Consumers
Power
Company

DOCKET 50-255 - LICENSE DPR-20 -
PALISADES PLANT - RAPID RESPONSE
TO ADDITIONAL INFORMATION REQUEST
ON THREE MILE ISLAND

ATTACHMENT

FIGURE 3.76 POWER, HEAT FLUX, AND SYSTEM FLOWS,
LOSS OF FEEDWATER FLOW

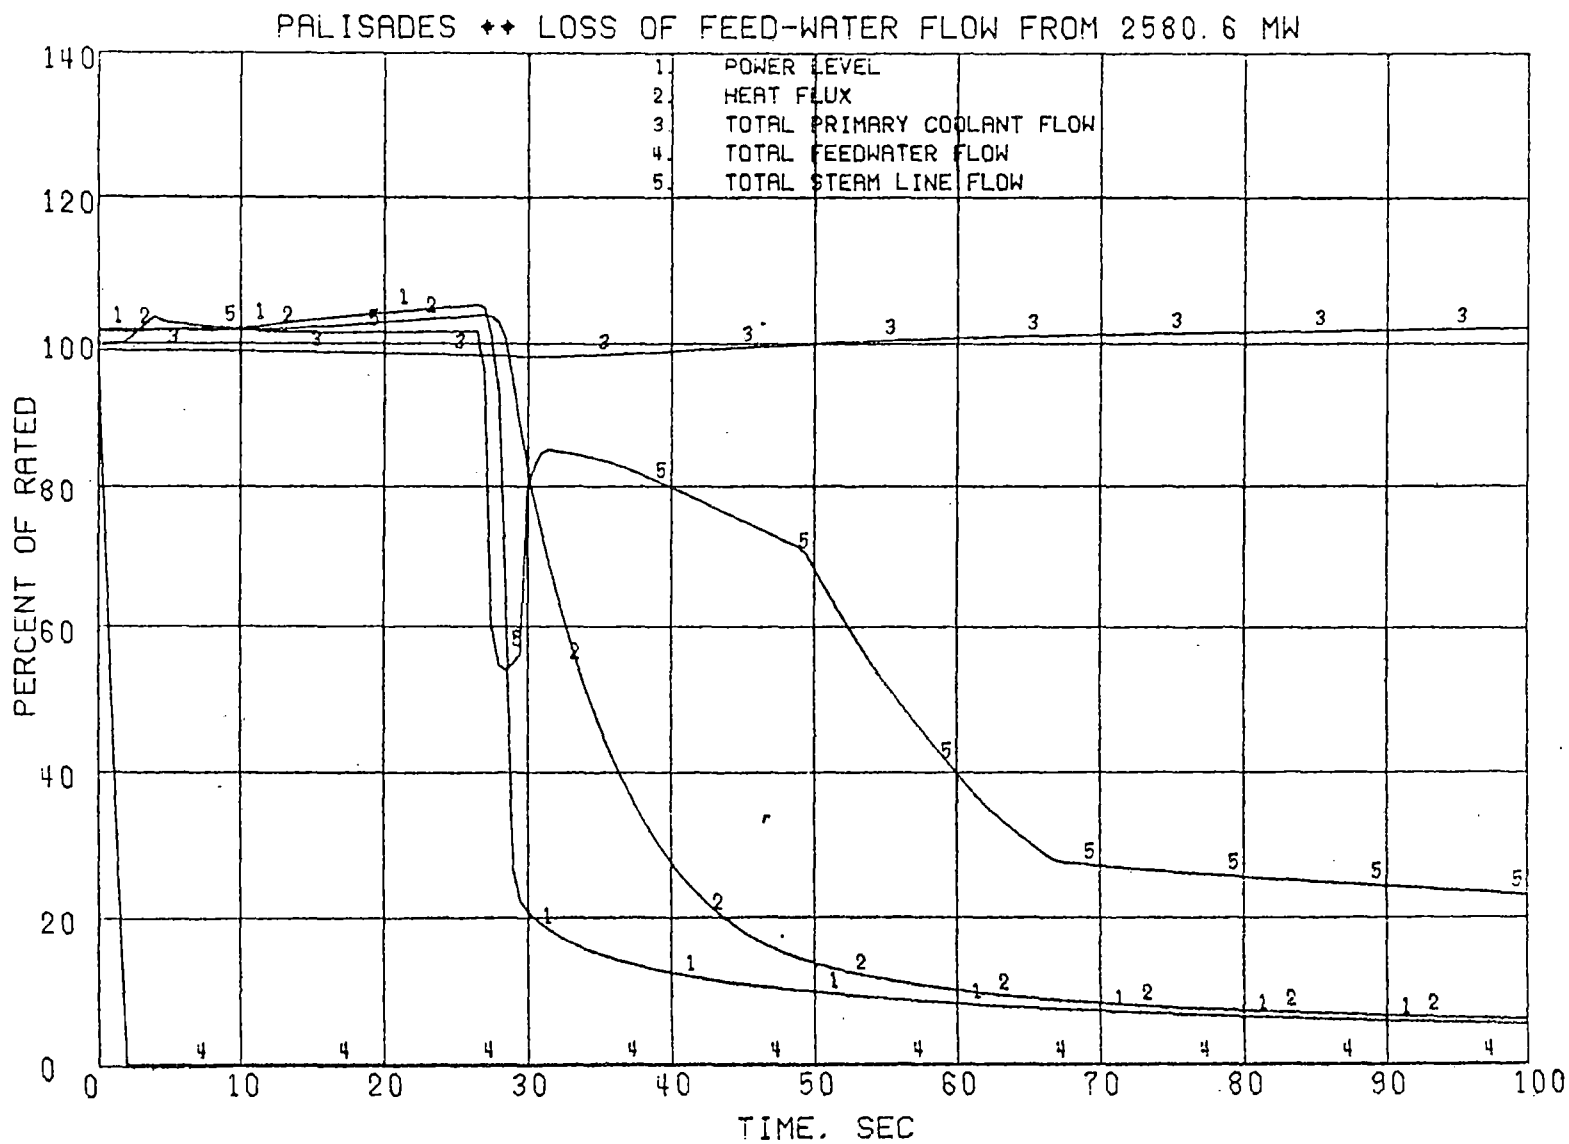
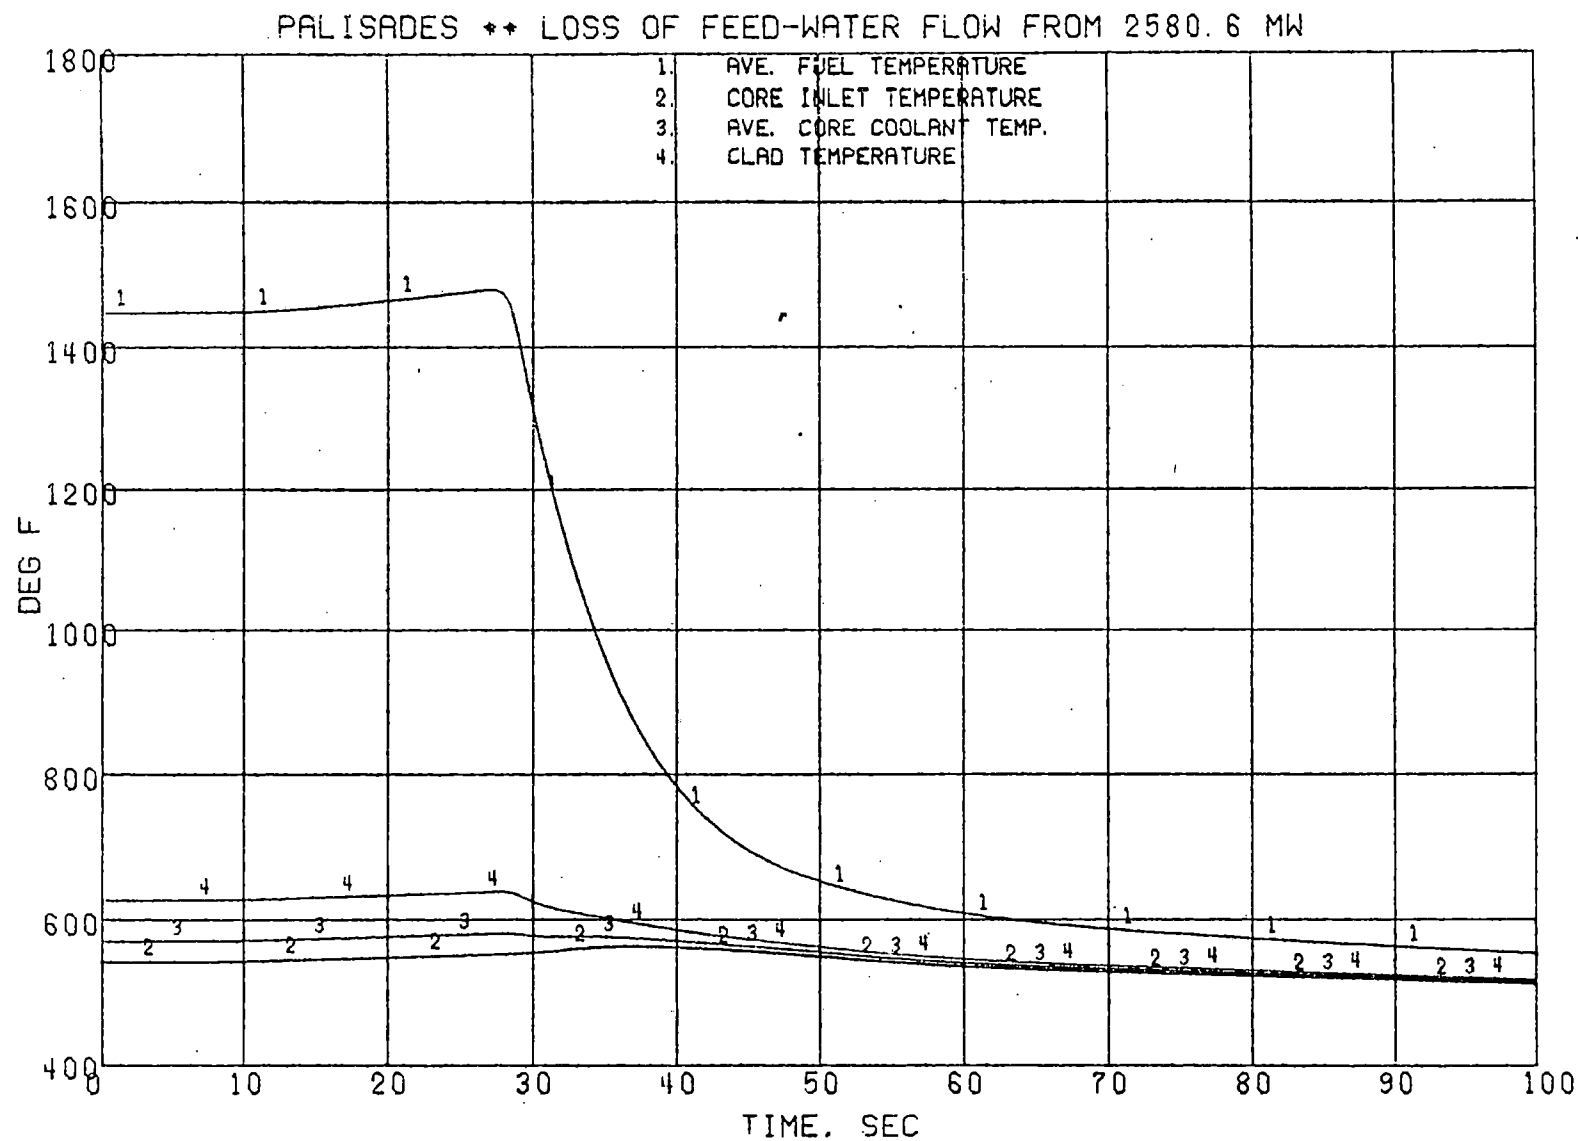
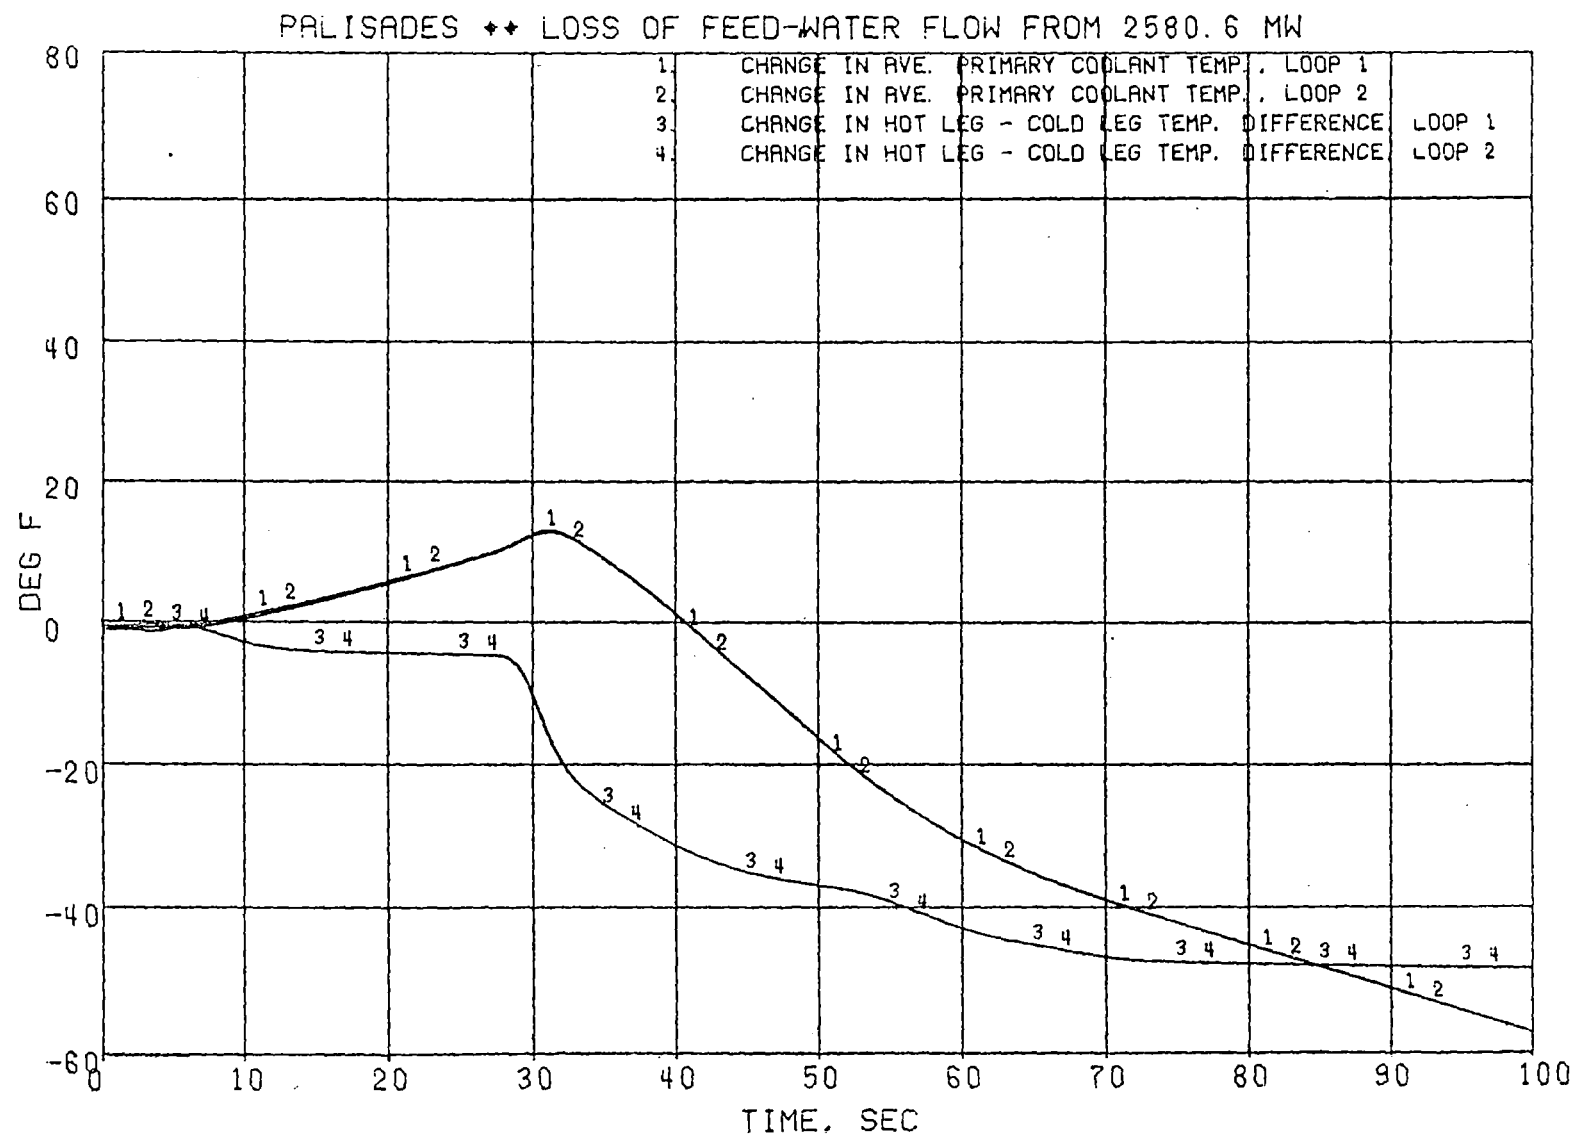
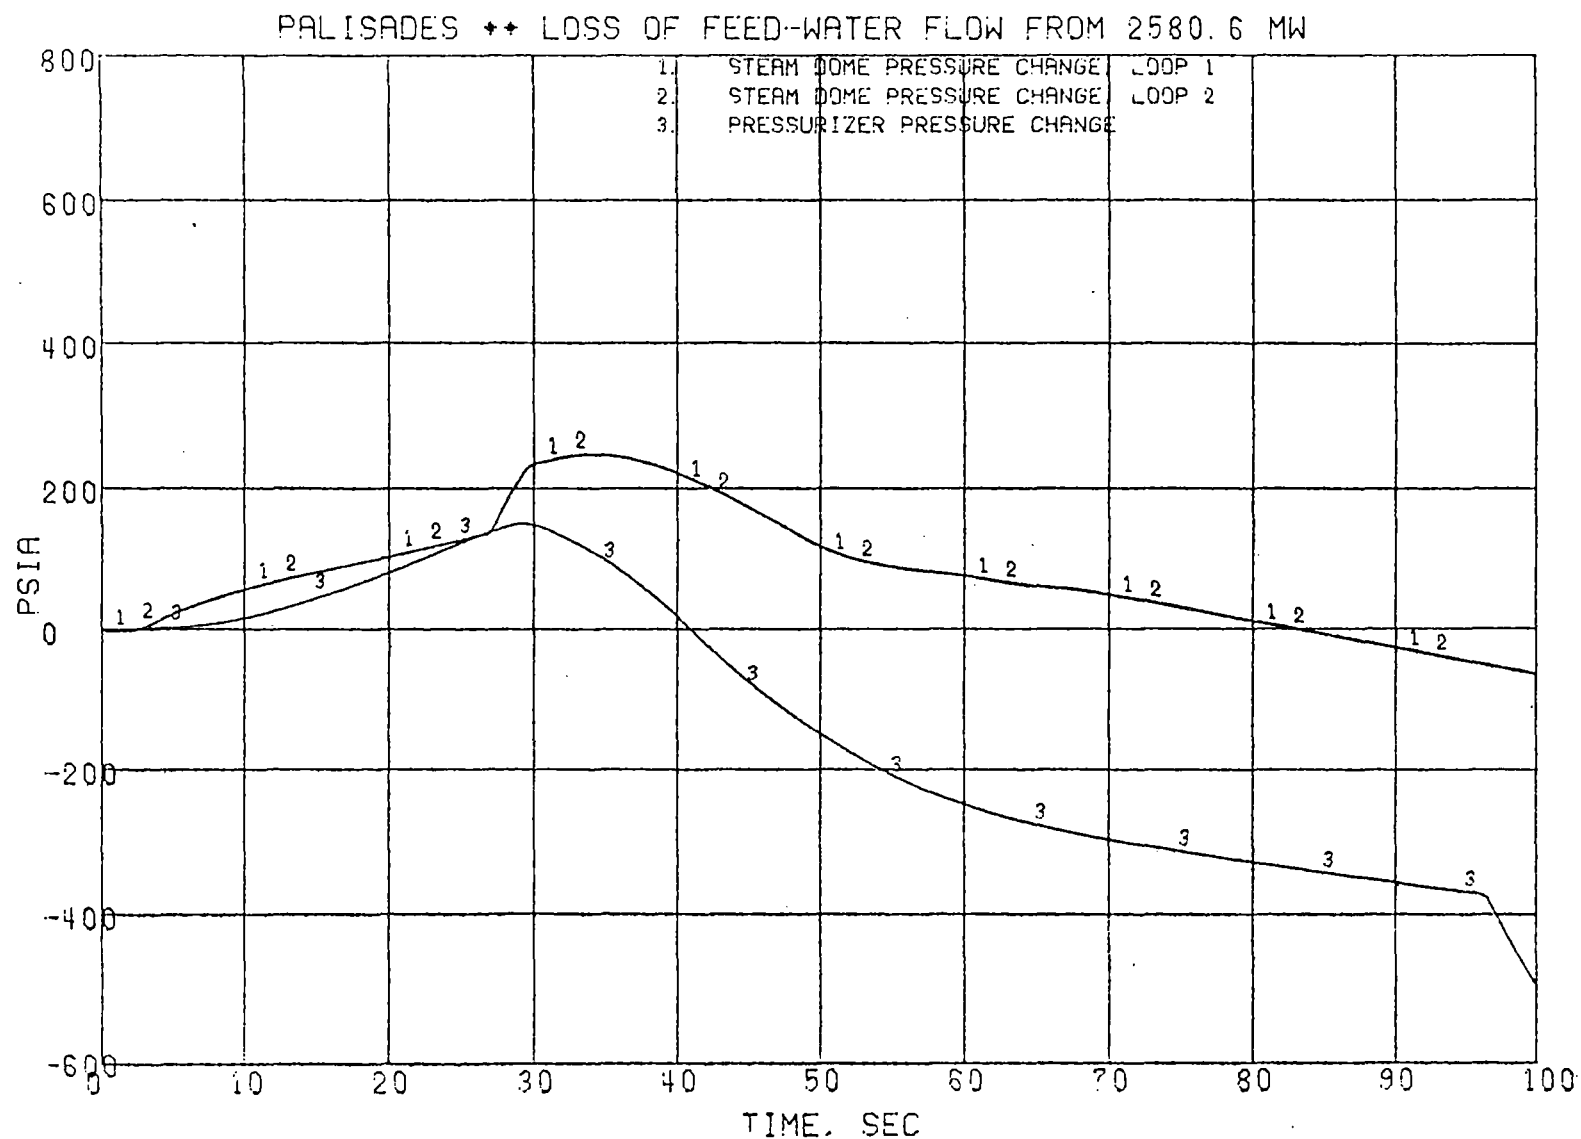
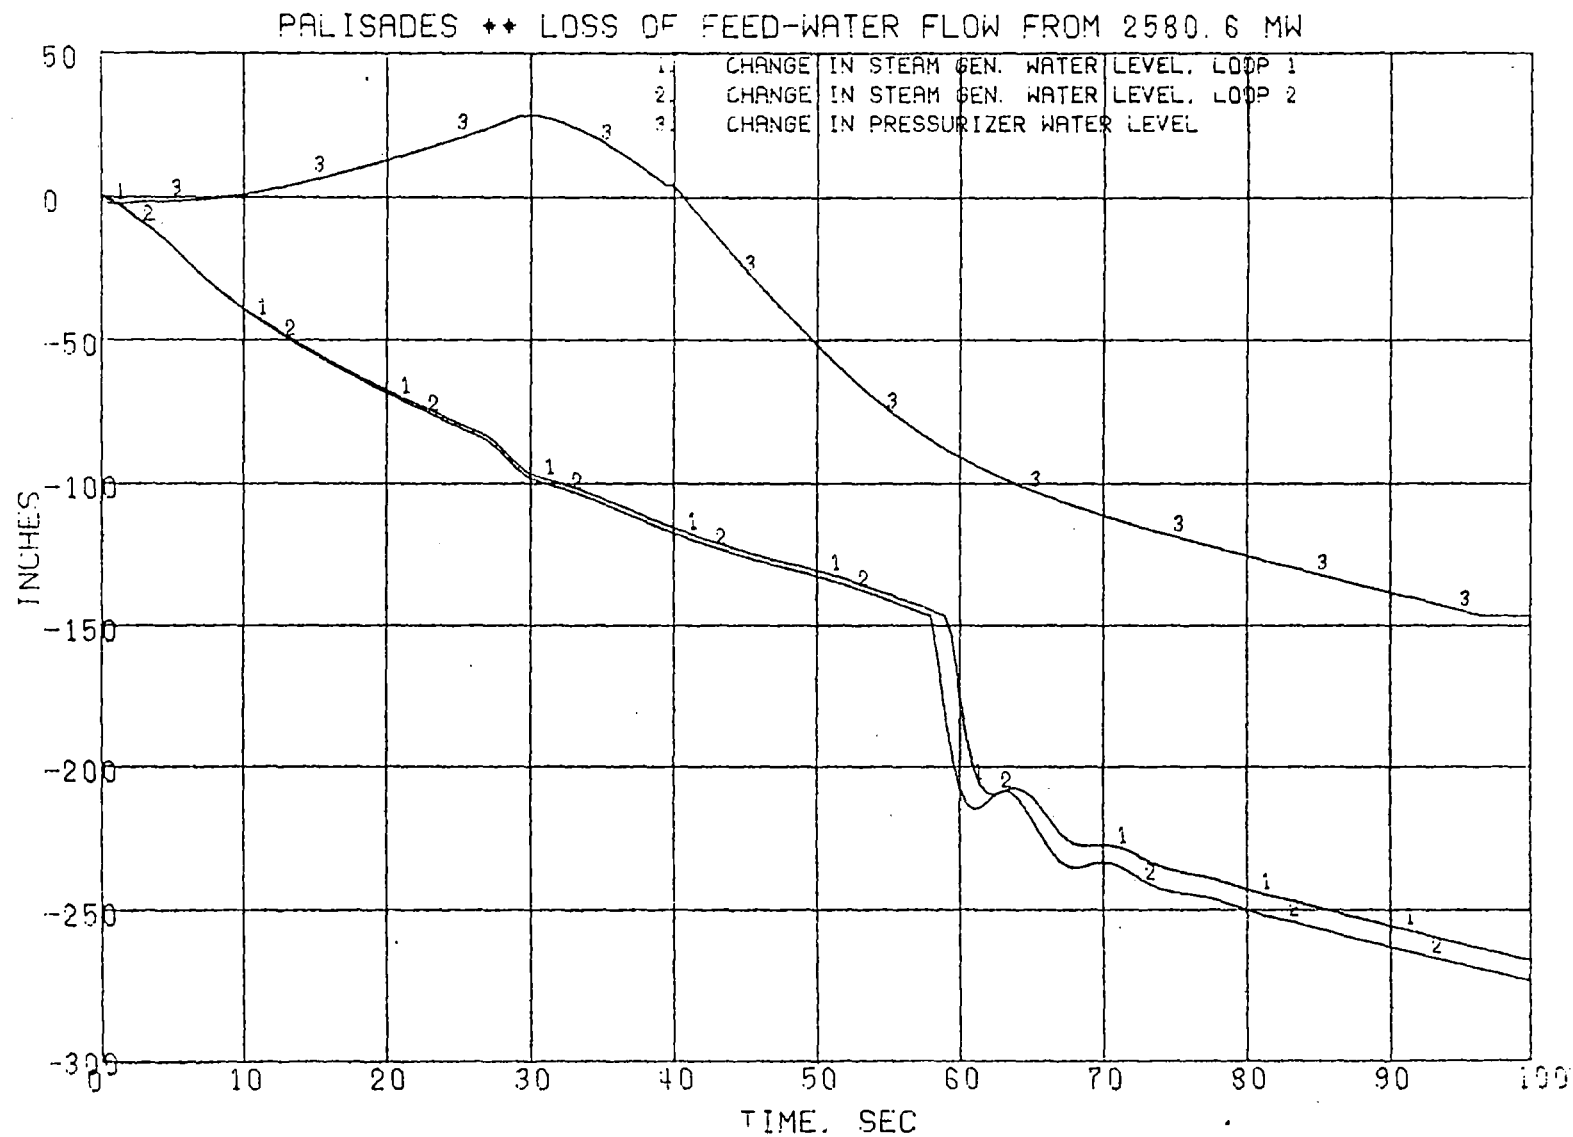
Provide a schematic diagram of the steam generator. Identify important characteristics. As a minimum provide the liquid level and volume for normal plant operation at power and the liquid level and volume at low level set point for reactor trip (for W plants low level with steam flow/feed flow mismatch) subsequent to a loss of feedwater. Describe the basis for this determination including a description and use of steam generator level span.

Figures 3.76 through 3.80 show the system responses during the loss-of-feedwater flow incident. The reactor trips at 26.7 seconds on low steam generator water level. This precipitates a turbine trip and activates

the atmospheric and condenser steam dump systems. An MDNBR of 1.65 occurs 0.3 seconds after trip. The atmospheric steam dump valves are controlled by the average primary coolant temperature following a turbine trip. The atmospheric dump valves are completely closed 38.3 seconds following the reactor trip, after which decay heat is removed via the steam bypass to the condenser. The water inventory in the steam generators is adequate to accommodate decay heat and pump heat for an additional 15 minutes, at which time the mass inventory of each steam generator is no less than 1700 lbs. Hence, the operator will have 16 minutes after the initiation of the incident to restore partial feedwater flow by activation of the auxiliary feedwater system.
